Subject: Oconee Nuclear Station
Docket Numbers 50-269, 270, and 287
Technical Specification Bases (TSB) Change

Please find attached revisions to TSB 3.8.3, DC Sources-Operating and 3.8.9, Distribution System - Shutdown, which were approved by Station Management on June 27, 2001 and implemented on July 3, 2001. These changes revise the LCO's of each bases section to include information that states the battery chargers are OPERABLE when they are energized or available to be energized during a power source transfer.

Likewise, you will find revisions to TSB 3.3.19 EPSL 230kV SY DGVP. This revision was implemented on July 12, 2001. This change revises the minimum switchyard voltage that ensures proper operation of loads during the ES actuation from 219 kV to 225,887 kV. The minimum switchyard voltage changes as a result of tap setting changes on transformers CT1, CT2, and CT3 by minor modifications OE-9368, OE-9369 and OE-9370. Minor modification OE-10264 changed the Degraded Grid relay settings, but did not change the minimum switchyard voltage listed in bases B 3.3.19.

Attachment 1 contains the new Technical Specification Bases page and Attachment 2 contains the markup version of t

APPLICABLE SAFETY ANALYSES

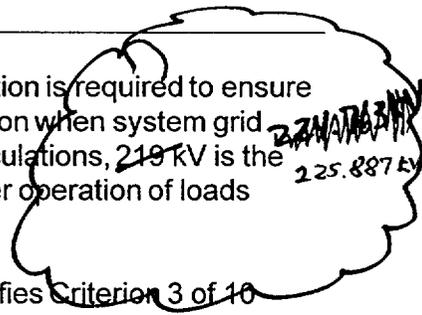
The EPSL Degraded Grid Voltage Protection function is required to ensure adequate voltage is available during an ES actuation when system grid voltages are not adequate (Ref. 1). Based on calculations, 219 kV is the minimum switchyard voltage that will ensure proper operation of loads during ES actuation.
